## HISTORICAL MEMORANDUM FOR THE RECORD

SolarMax Adaptive Reuse Design Assessment, 3080 12th Street, Riverside CA 92507

Memorandum Addendum No. 1 Issue date 19 March 2013

Historical Architectural Assessment and Adaptive Reuse Design consultation for proposed SolarMax reuse of the former FMC building complex, Riverside CA (Riverside Cultural Heritage Landmark #102)

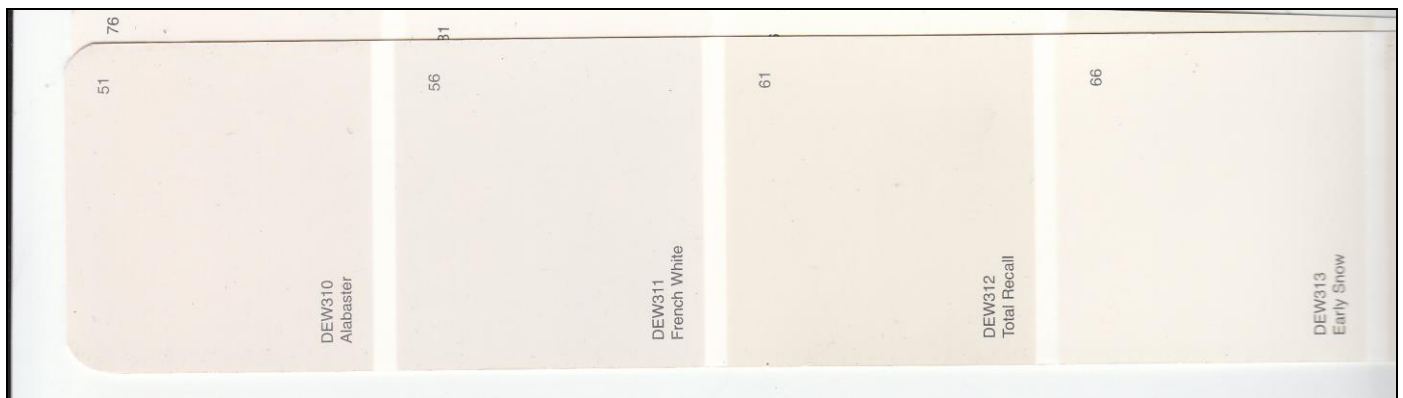
A paint color proposal was forwarded from JW Associates to Planner Brian Norton on 14 March. It was forwarded to GTL|HA by Norton, who identified the selection proposed as Sherwin Williams' color # SW 7666, "Fleur de Sel." According to Norton, "it is fairly light grey in color."

A paint color was secured from the manufacturer, shown here for comparison with the color sample matched to the cement plaster:

Exterior plaster: proposed new plaster color to match original plaster finish from JWL Associates.  
Matte finish.

Sherwin Williams color match proposed: SW 7666, "Fleur se Sel"

Exterior plaster: color matched to original plaster material; matte finish.

Dunn Edwards/ Munsell color match: DEW 312, "Total Recall"; Munsell 1.13Y/8.9/1.2

It should be noted that digitized reproductions of color chip cards are inexact at best. Colors must be matched by actual painted surfaces on sample boards. Review of these colors suggests that the minimally invasive, least-impact approach would be to repaint a similar color to that present in the original cement plaster.

It is recommended to repaint the exterior plaster surfaces throughout as the color forwarded to Planning by JWL Associates: Sherwin – Williams color number SW 7666, color name "Fleur de Sel" This color is fairly close to the original exterior integral-color plaster used historically. The light reflective value (LRV) given for this color is 72 on a 100 scale; the color match established in the HMFR color match is 76 on a 100 scale. A lighter color value is preferable in this instance; these are close. The Sherwin – Williams samples do not indicate a Munsell number. This recommendation is conditional upon review of an actual paint sample against the exposed areas of extant original plaster color.

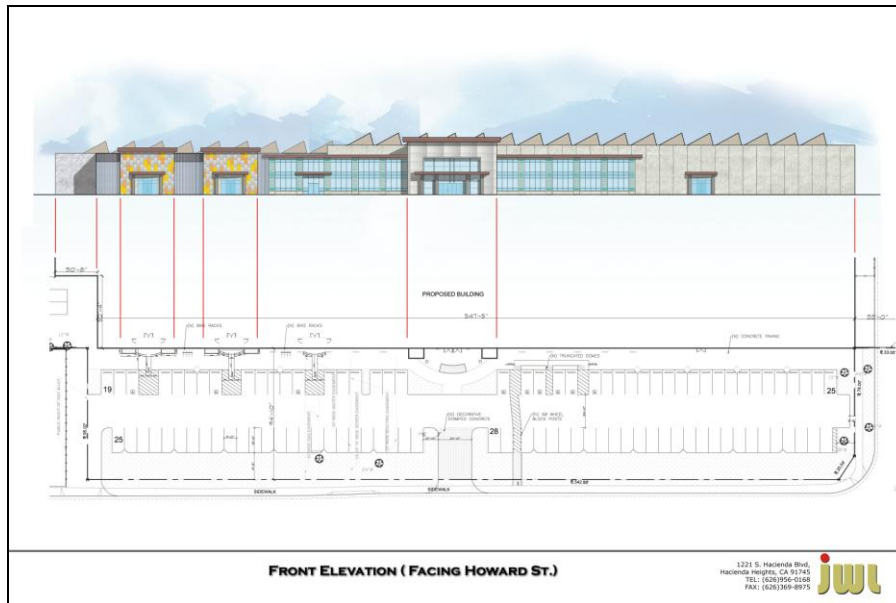
4>Two things I am researching now is the reversibility of the proposed sandblasting, and the cutting in of the plaster to create a new joint.

6>The added joints appear to be purely an aesthetic request, and one that may be difficult to justify as detailed. So much of the secondary façade has already been “decorated”, and while the joints may be considered as not as large an impact as the massive new entrance feature, it does compromise the one remaining “large” building original identify that remains. The fact that it was retaining SOME of the planar, blank façade appearance is what in my opinion allowed the decorative devices employed elsewhere to be deemed acceptable.

7>The real problem and direct, unjustified impact is in cutting the wall for the proposed scoring appearance. This will in fact reduce the viability of the original plaster wall surface, by creating effectively three joints. Two are along the cut lines at the sides of the joints, where the trim width would need to be accommodated. Then there would be the narrow joint itself. Old plaster to new plaster interactions effectively are difficult to achieve as shrinkage cracks occur where the new material has dried, and will present the probability that new cracks would be created as the integrity of the plaster walls has been compromised. These also pose risks for water penetration. If a lively appearance is desired I would Strongly Recommend NOT utilizing non-recoverable/reversible detailing strategies. I would consider that painting these lines would accomplish the same objectives as the client has, and not be detrimental to the original integrity of the landmark.

As initially proposed this non-reversible detail is not conforming to these standards, and was recommended by GTL|MHA to be reconsidered as a more appropriate re

As this detail has been further considered since the initial emailed response, the initial request for irreversibly damaging the historical fabric by slicing the façade at ten-foot centers was withdrawn. Below is the proposed façade color and vertical markings as received for review on 03-14-

With this detail now reconsidered and proposed as added vertical elements created with an alternate paint color in contrast to the typical field paint color, it now uses a reversible approach to best comply with the intent of the Secretary of the Interior's Standards for Rehabilitation. Minimizing permanent alterations to the building is recommended.

It is recommended to paint the stripes a color consistent with the extant darker grey color. Its color value will read as a shadowline, consistent with the client's intent to modify the uniform appearance of the historical façade.

From the perspective of visually not counteracting the character-defining feature of the *“long, blank façade,”* the spacing of the paint-applied reveals was studied. The elevation provided by JWL Associates appears to show an alignment of the spacing of every second reveal with the sawtooth roof elements above and set back from the façade. This creates a denser spacing than is evident anywhere else at Plant No. 2, and the parapet height extensions with the set back does not allow this relationship to be understood from typical vantage point views. It is recommended to reference a more understandable relationship that was also employed in the spacing of the louvre screen wall additions at the southern part of this façade: the column spacing behind the plaster walls.

Therefore is recommended to widen the distance between paint-applied reveal spacing to approximately 20 feet 9 inch in width, aligning with centerlines of the columns.
